**Ministerial Planning Referral: TPM-2023-3**  
**899-913 Collins Street, Docklands**

21 November 2023

### MINISTERIAL PLANNING REFERRAL

Figure 7 – extract of Plan of Subdivision 545345Y

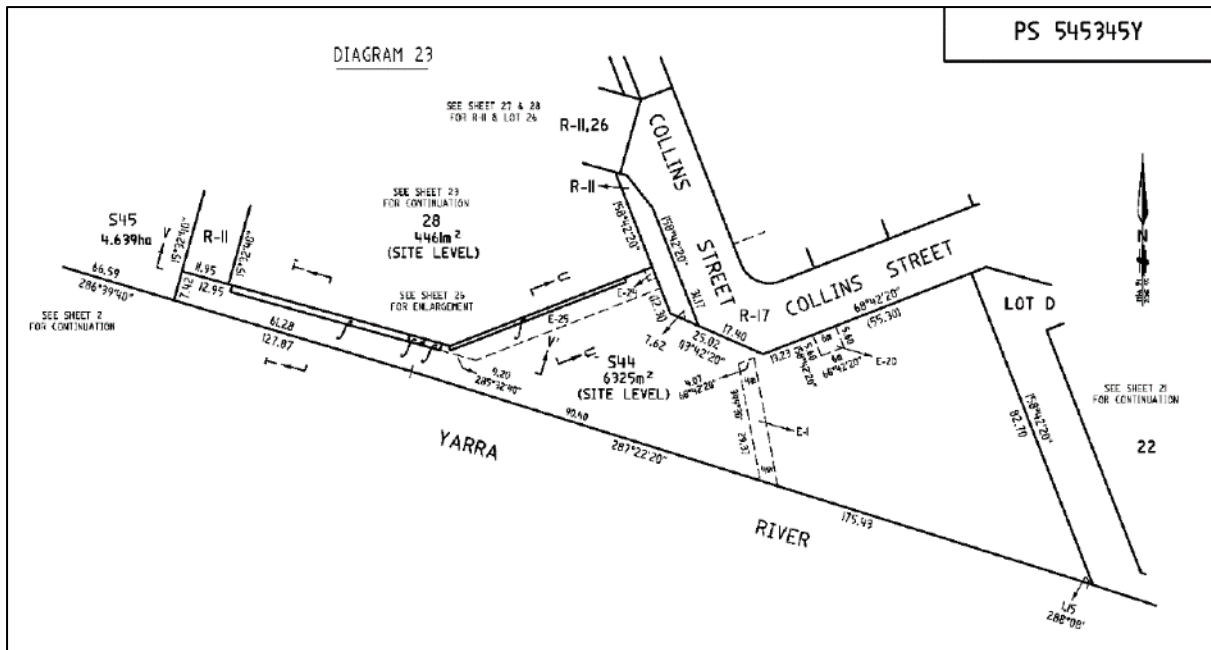
Plan of Subdivision 545345Y indicates the Site is burdened by easements E-1 and E-20 which benefit Powercor Australia Ltd and City West Water Corporation. As discussed below, the City of Melbourne's land survey team has recommended conditions (should a permit issue) that evidence is provided that the easements have been removed, varied, or approval has been given to build over them prior to the commencement of development.

Figure 10 – excerpt of the Ground Floor Plan (TP-21-000) prepared by Cox Architecture dated 14 September 2023 (Rev. 2)

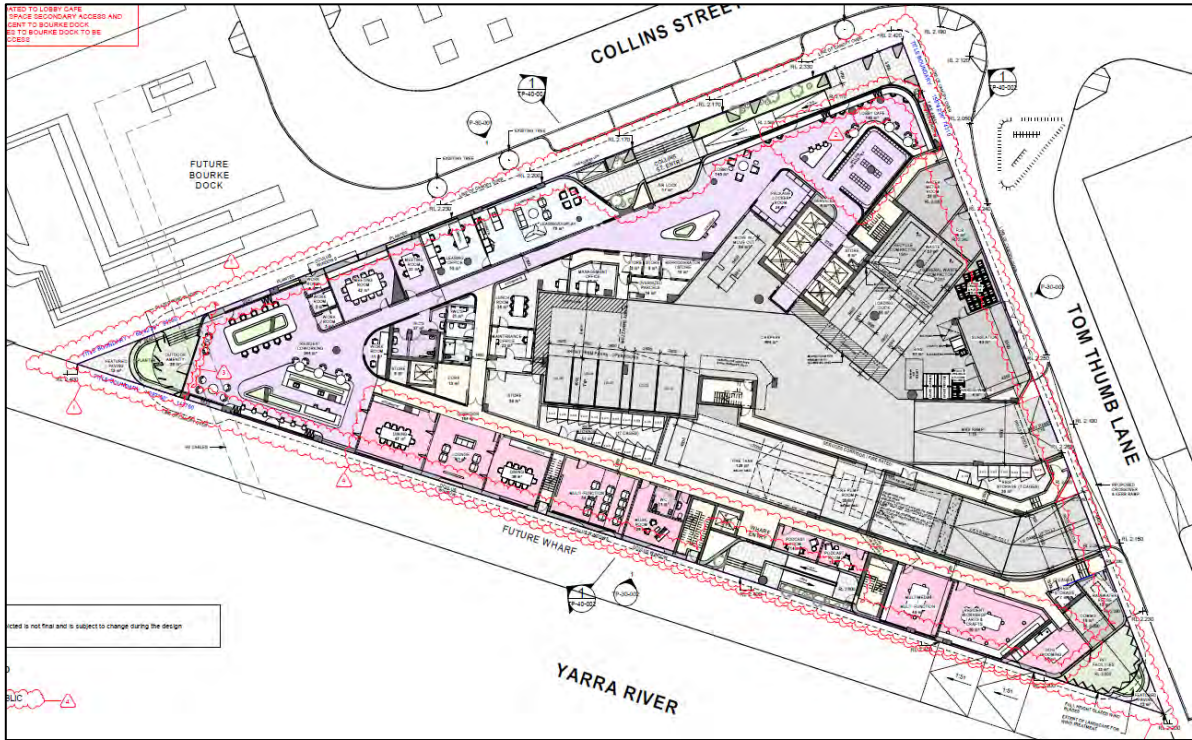
Between July and September 2023, the applicant provided a response to the Request for Further Information and provided responses to the City of Melbourne's internal experts. As part of those responses, on 15 September 2023 the applicant provided (amongst other things) an updated ground floor discussion plan prepared by Cox Architecture Pty Ltd which nominated a food and drink premises within the ground floor of the proposed building to the corner of Collins Street and Tom Thumb Lane and the provision of public stairs and seating on the south-west corner at the corner to Bourke Dock park and Australia Wharf. The discussion plans were accompanied by the accompanying proposed condition:

- a. Revised ground floor design strategy as shown in the drawings, labelled 'Discussion Plans', prepared by Cox Architecture dated 15 August 2023<sup>3</sup>, which is to include:
  - i. nomination of café space at the corner of Collins Street and Tom Thumb Lane; and
  - ii. provision of stairs and seating on the south-west corner at Bourke Dock and Australia Wharf'

Figure 25 – extract of the proposed ground floor plan (TP-21-000) with proposed and potential (from the leasing office) connections to Bourke Dock park

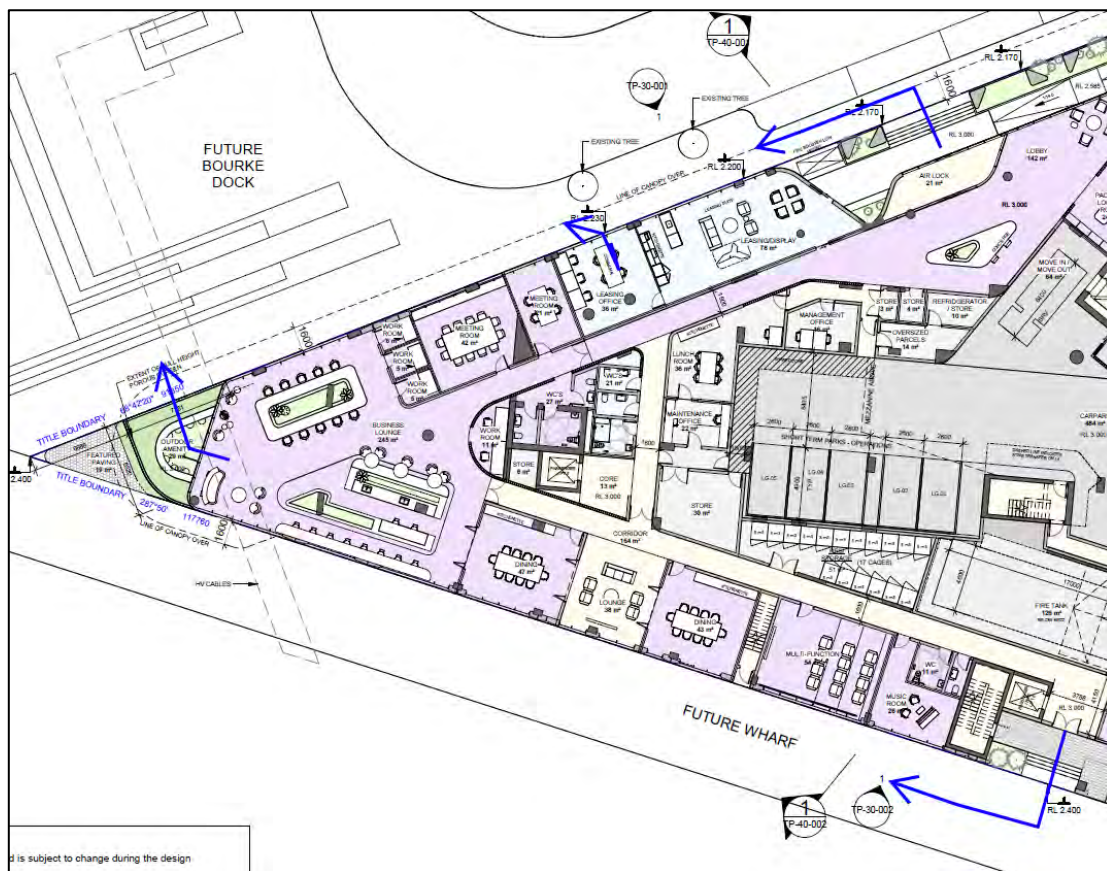
- o The proposal provides for reasonable connections to the adjacent future Bourke Dock park and future Australia Wharf which are public spaces that will be suitably further activated by the ground level of the proposal. As identified in the Development Plan, active interfaces to the public spaces will create '...the potential for community activities to spill out into the park and provide a direct exchange between building and public realm'. It is considered that this objective is met.

Figure 27 – apartment C04.1

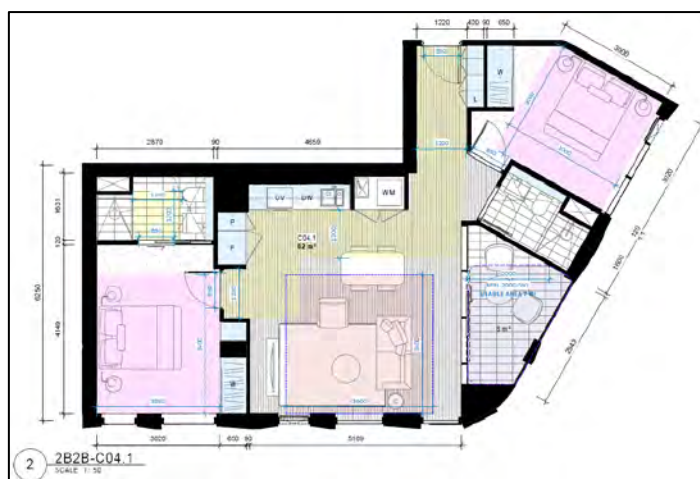
84 per cent of the balconies meet the Standard. The shortfall apartments are typically non-linear shaped apartments (including apartment C04.1 as the figure below shows). These non-linear apartments are considered to meet the Objective of the clause given the areas remain useable and functional and there is an exceedance of the communal indoor and outdoor provisions of clause 58.

Figure 28 – Figure 6b: Wind Tunnel Results – Ground Floor Plan (Source: Pedestrian Wind Environment Study)

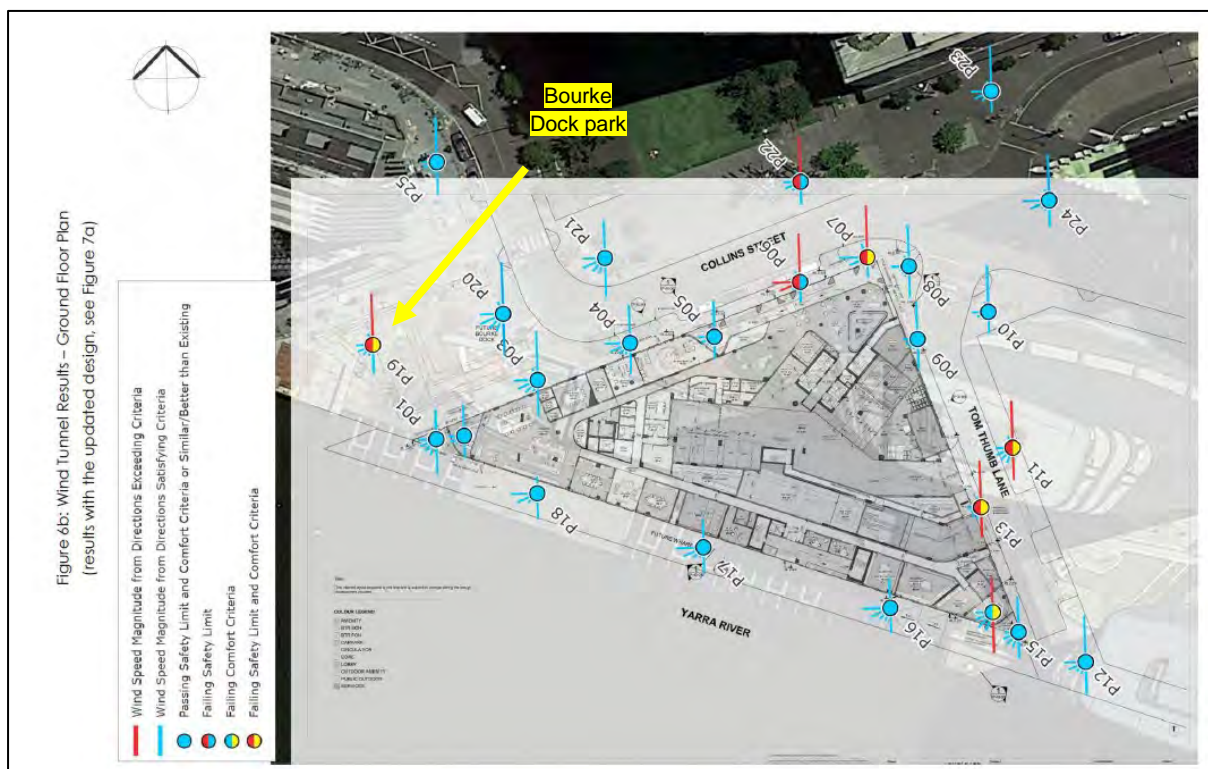
However, the report provides that the future Bourke Dock park fails the safety limit and the comfort criteria. Conditions such as this must be avoided for new public spaces. As such, by way of permit condition (should a permit issue), it is recommended that further review of wind impacts to future Bourke Dock park be undertaken to ensure the park meets relevant safety and comfort standards for future users.

Figure 29 – proposed 11:00am shadow diagram

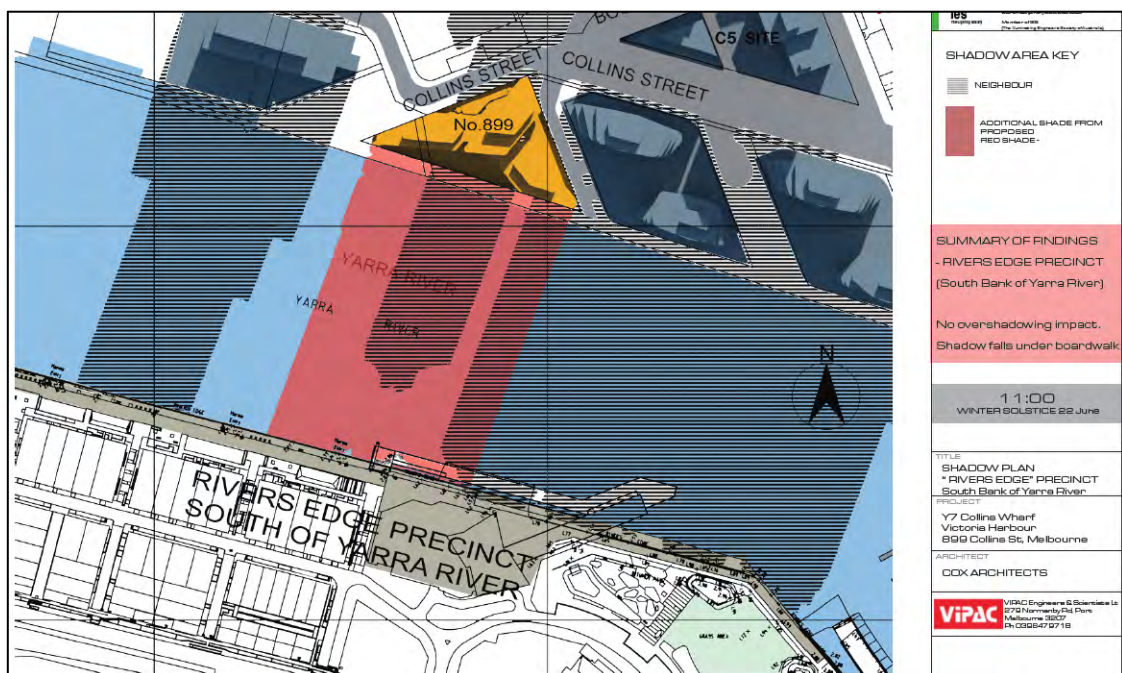
The proposal is supported by a detailed Overshadow Analysis prepared by VIPAC Engineers and Scientists Pty Ltd which demonstrates the proposed shadow across the Yarra River at the required times. The analysis depicts shadows close to the south bank of the Yarra River between 11:00am and 11:15am which is accompanied by a written submission by Urbis Pty Ltd which states that '...the shadow falls under the boardwalk.<sup>13</sup> There are no sections accompanying the shadow assessment providing further information on this matter. Given that overshadowing of the south bank between 11:00am and 2:00pm on 22 June is prohibited, a planning permit condition will be recommended to ensure that the requirement is met.
